CITY OF ALBUQUERQUE

April 3, 2007

Re: North Gateway Drainage Report and Conceptual Grading and Drainage Plan

Engineer's Stamp dated 3-1-07 (B18/D004)

NORTH GATEWAY			
CONCEPTUAL GRADING AND DRAINAGE			
MARK GOODWIN & ASSOCIATES, P.A. CONSULTING ENGINEERS P.O. BOX 90606 ALBUQUERQUE, NEW MEXICO 87199 (505)828-2200, FAX (505)797-9539			
Designed: JM	Drawn: SPS	Checked: DMG	Sheet 1 of 1
Scale: 1" = 60'	Date: 3/6/2007	Job: A06062

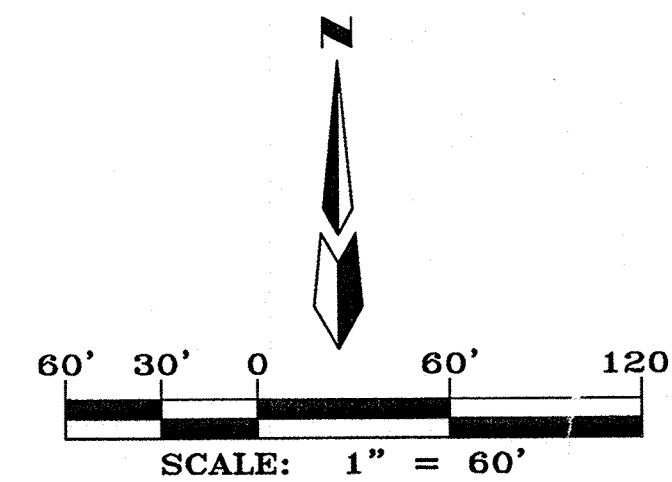
1. Banks approved
2. When dirt work
go west on
San Mateo

Stamp
date
from
Report
3-1-07
CC
